## The Dunes

DRAWING  
**SITE PLAN & DEVELOPMENT DATA**  
PROJECT NO. **2685-366** DRAWING NO. **DA-01** ISSUE **C**

**SECTION 4.15 EVALUATION FOR DA2021/0547**  
**- Lot 16 DP 1261938**  
**- 3 Dunes Court YAMBA NSW 2464**

**Proposal:** Development Application DA2021/0547 was lodged on 19 July 2021 for the construction of 5 multi units dwellings and swimming pools. In response to a request for further information regarding compliance with the Development Control Plan in terms of parking and private open space the Applicant has amended the proposed development. The amended design has resulted a reduction of 1 unit from 5 to 4 and one unit becoming single storey instead of 2.

**LANDSCAPE PLAN**  
**1:200**

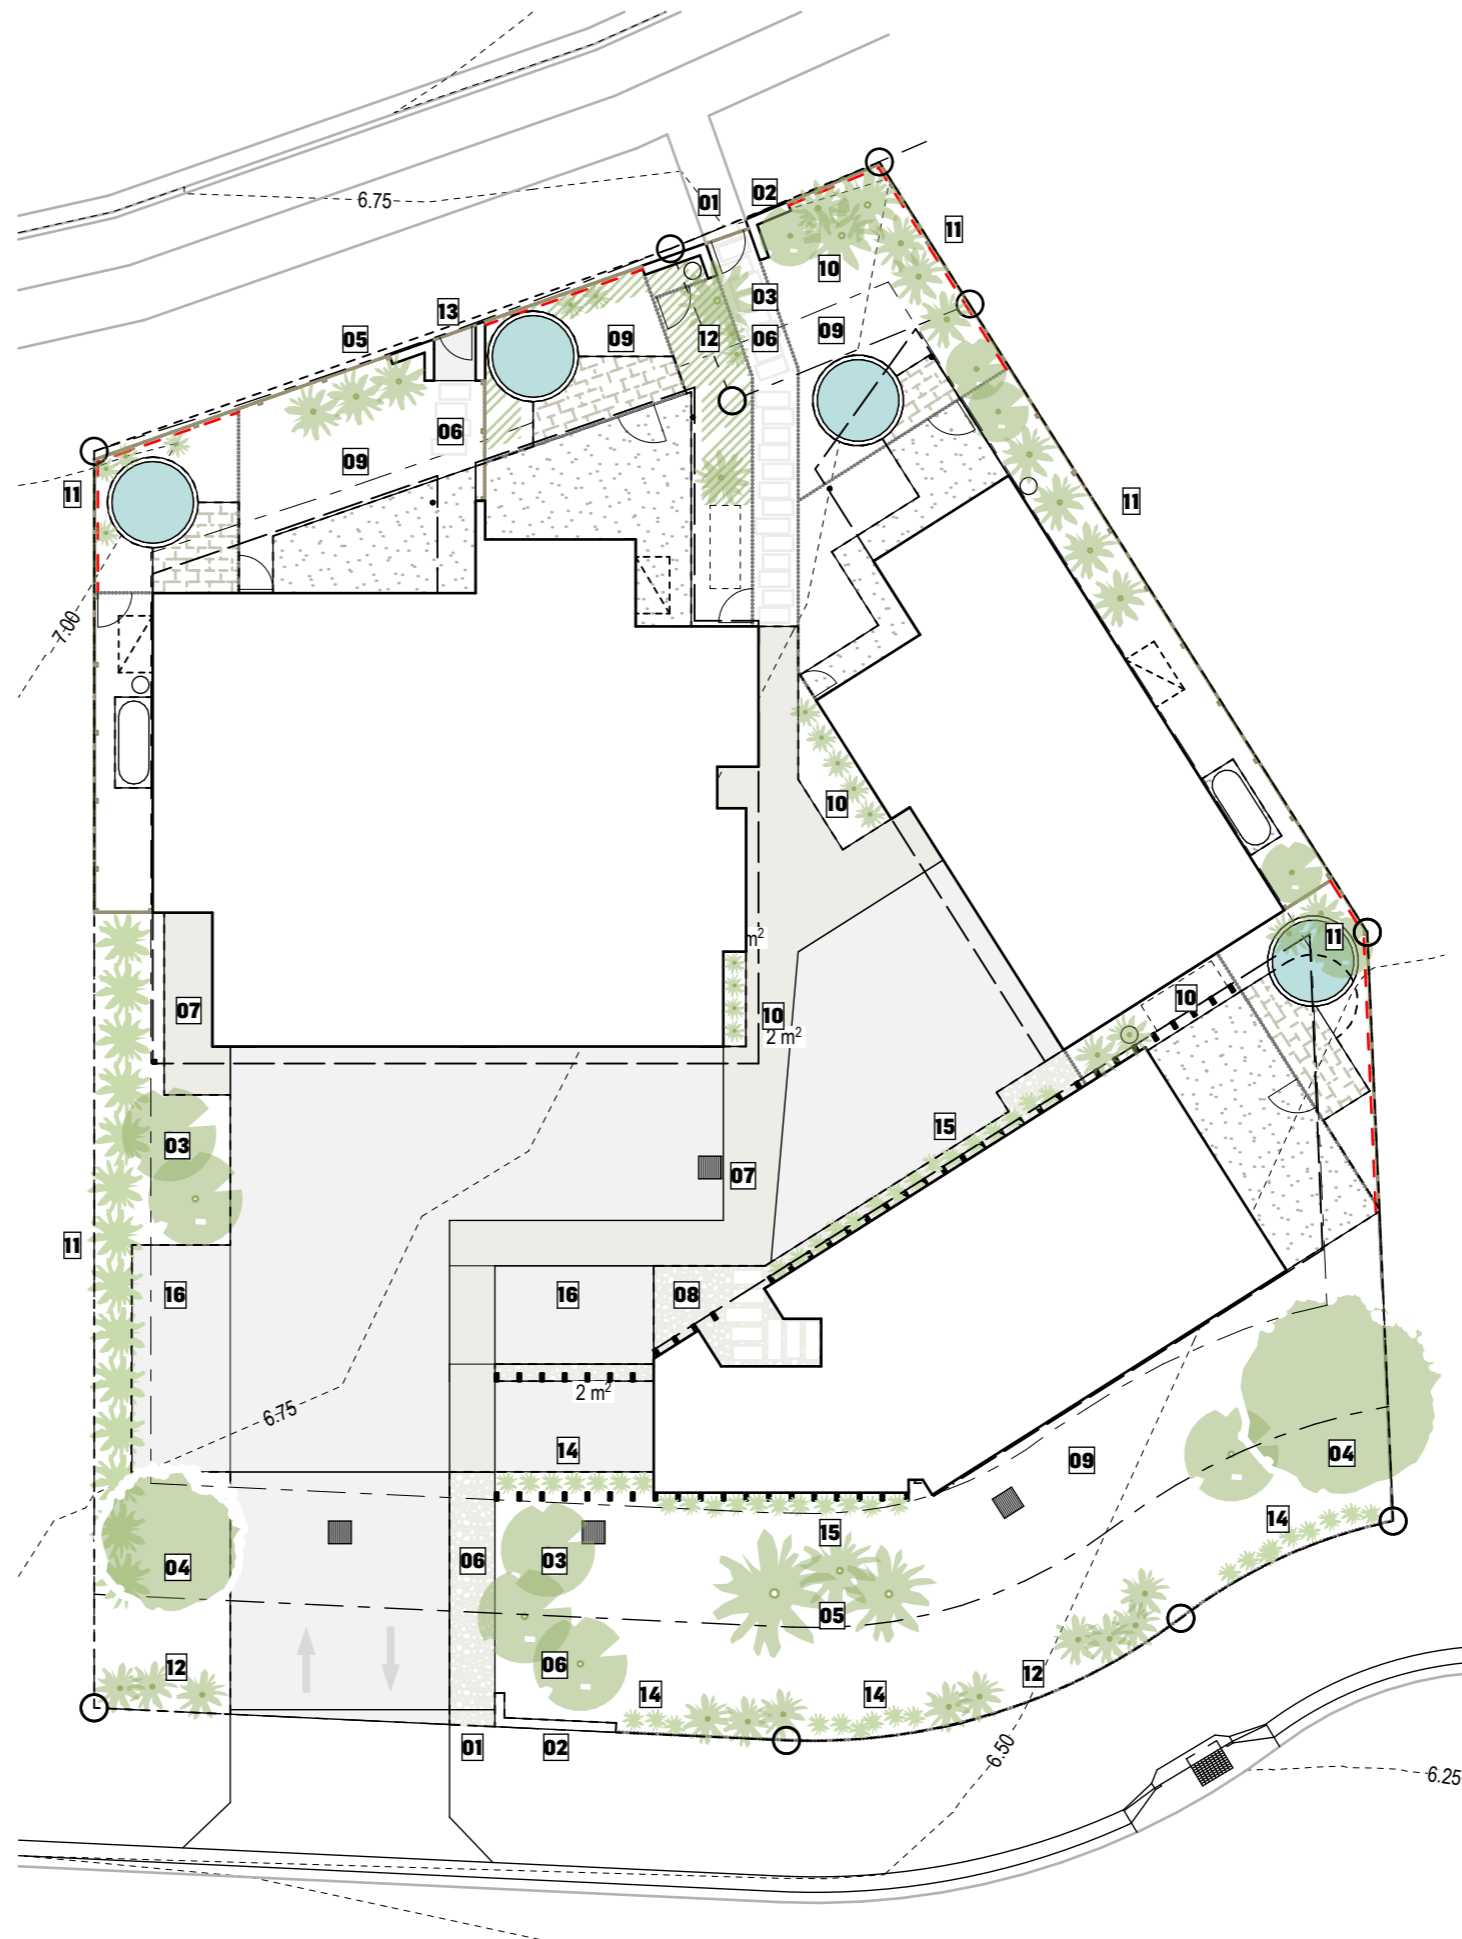
Clause	Control	Complies
C4 Streetscape Requirements		The revised design including removing a unit and Unit 4 going from two storey to single storey has reduced the overall bulk and scale of the development to Dunes Court. Further, the landscape plan submitted includes larger tree species and a landscaped trellis for part of the Dunes Court elevation which will help soften the overall impact on streetscape.
C5 Building and Design Requirements		Cut and fill has been minimized and valid BASIX Certificate has been submitted.
C8 Types of Residential Development	Multi Unit Housing	Permissible in the zone
C11 Minimum Site area for multi unit housing	nil	Site is able to accommodate proposed use.
C13 Landscaping – SP3 Zone	Landscape Plan to be Submitted	A landscape plan has been submitted with the application, the number and type of species are considered to be suitable.
C14 Landscaped Area – SP3 Zone	35%	35% of the subject site is landscaped, this excludes pools from the calculation and has taken a 50% area for paved and gravel walk ways where ground covers will be planted between.

The subject site is zoned SP3 Tourist under the LEP which provides for a mix of residential, tourist and commercial land uses. The Dunes Estate has largely been developed into single detached dwellings however the objectives of the zone direct land uses towards tourist orientated development or land uses that compliment tourism. The proposed density of the site is consistent with the surrounding smaller lots of the Beachside, Links and Sands developments in the surrounding area. The revised design including removing a unit and Unit 4 going from two storey to single storey has reduced the overall bulk and scale of the development to Dunes Court. Further, the landscape plan submitted includes larger tree species and a landscaped trellis for part of the Dunes Court elevation which will help soften the overall impact on streetscape.
